# PRODUCT UPDATE

Number 7  
Revision 1

## NEW BELT GUARD FOR ACE PTOC AND PTOC-150 SERIES PUMPS

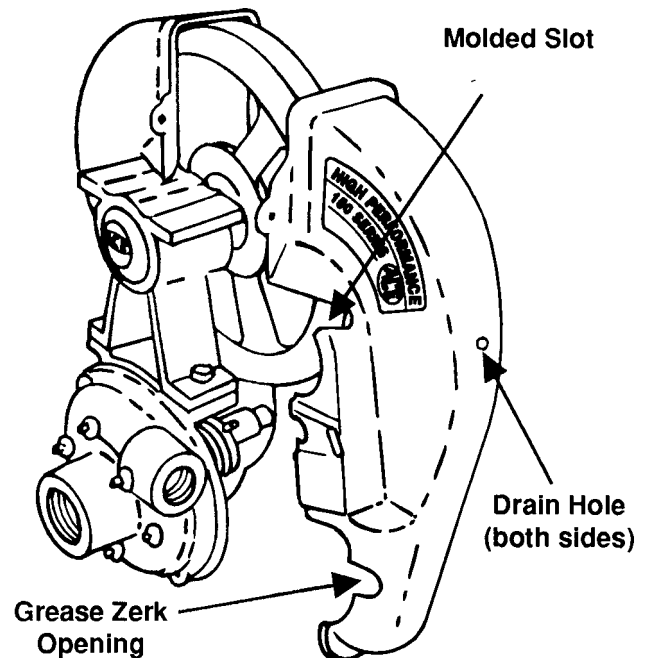
The BGKB belt guard that has been standard on all PTOC and PTOC-150 Series pumps has been superseded by a revised design that became standard in August, 1994. The revised design fits all past and present PTOC pump models.

- Increased pulley clearance.
- Molded slot to accommodate base-mounted pumps.
- An opening to provide access to the zerk fitting on the idler arm; now it can be greased without removing the belt guard.
- Drain holes on both sides of the guard to provide drainage when the pump is mounted on the sprayer in a horizontal position.
- Belt guards for 150 Series pumps will feature a 150 Series logo pad printed on them.

The new belt guards can be easily identified by the squared-off radius where the guard fits around the pulley.

The new belt guards will have the molded slot regardless of whether they will be installed on PTO mounted pumps or base mounted pumps. The BGKB and the BGKB-150 belt guard kits are physically interchangeable except the BGKB-150 is marked with 150 Series logo.
